NSD-NRC-96-4739
DCP/NRC0528
Docket No.: STN-52-003

SUBJECT: DRAFT MARKED UP OF AP600 PRA CHAPTER 54

Enclosure 1 to this letter is a draft mark up of Chapter 54 of the AP600 Probabilistic Risk Assessment (PRA) covering the low power and shutdown PRA assessment. The PRA section has been revised to incorporate commitments Westinghouse made in responses to RAIs.

Enclosure 2 to Westinghouse
Letter NSD-NRC-96-4739
June 6, 1996

04/10/96 10:55:12
LCSP_OIL
LOSP AT UET CAUSES DILUTION
Page 1 of 1

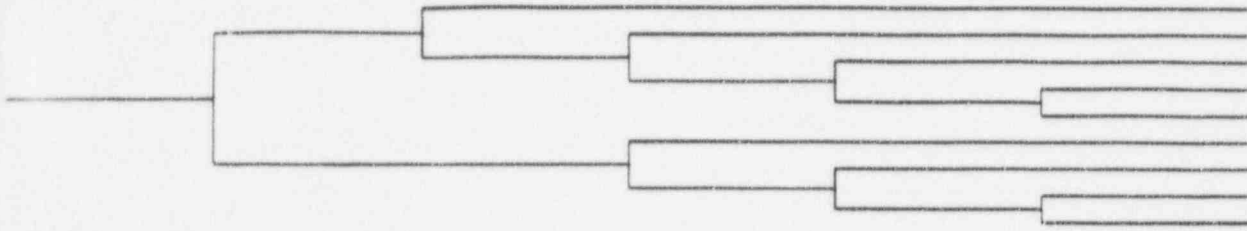
The LOSP event tree indicates only end states 5 and 9 could result in dilution of the core; the estimated frequency of these end states are 8.13×10^{-16} and 8.13×10^{-17} respectively. As above, these end states are significantly smaller than the shutdown core damage frequency (CDF), so their value should not significantly affect the shutdown/low power CDF.

HOTSD
DILUTION DURING STARTUP FROM HOT SHUTDOWN
Page 1 of 1

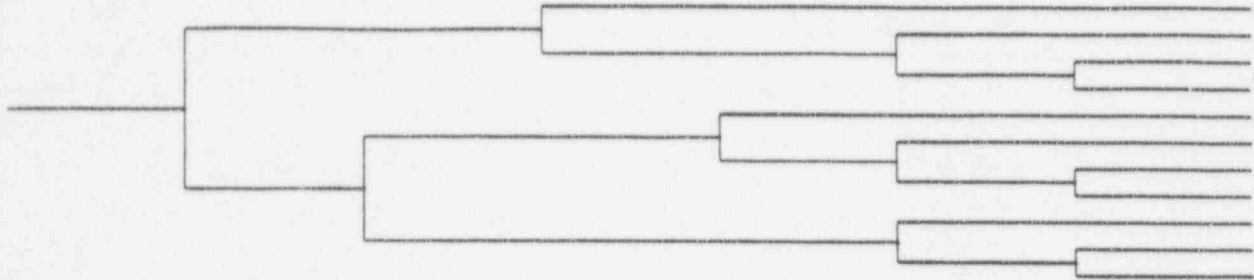
b. CVS Water Injection and Boron Dilution during Plant Startup

Figure 54-1

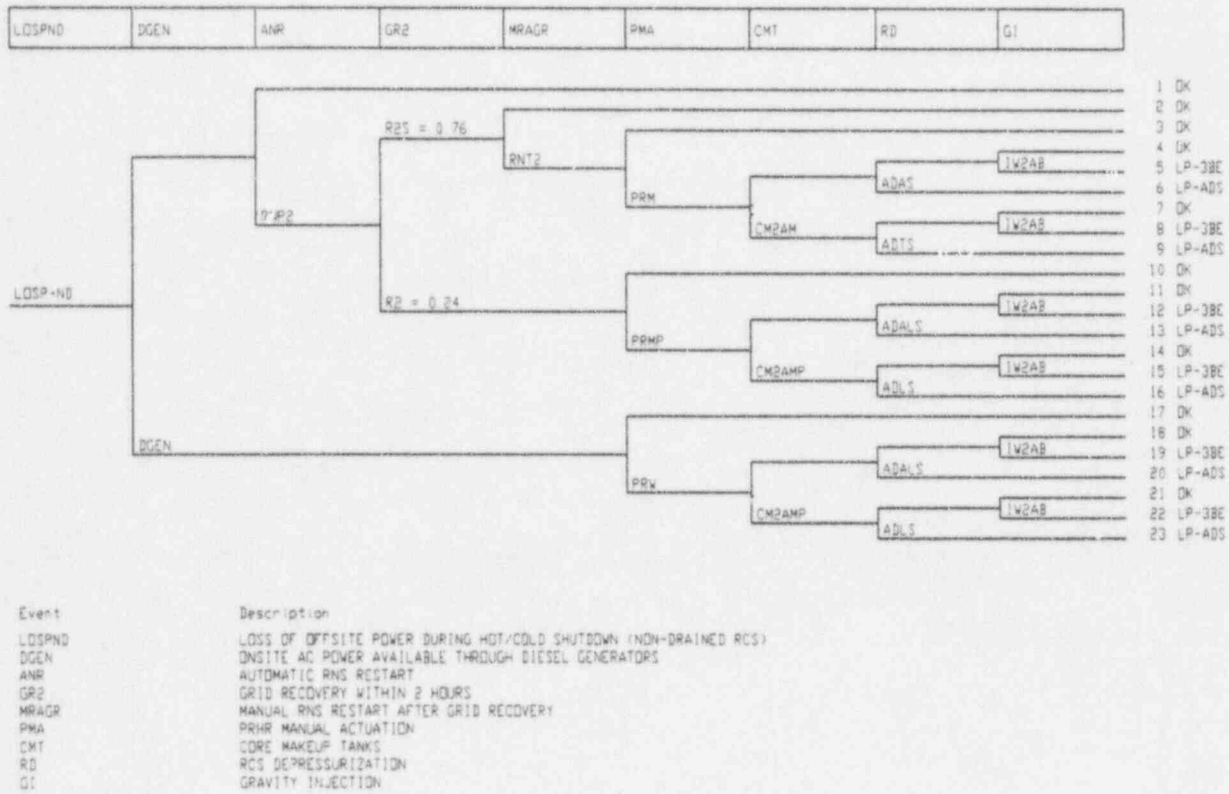
LOSP During Hot/Cold Shutdown (RCS Filled) Event Tree

Markup
June 7, 1996
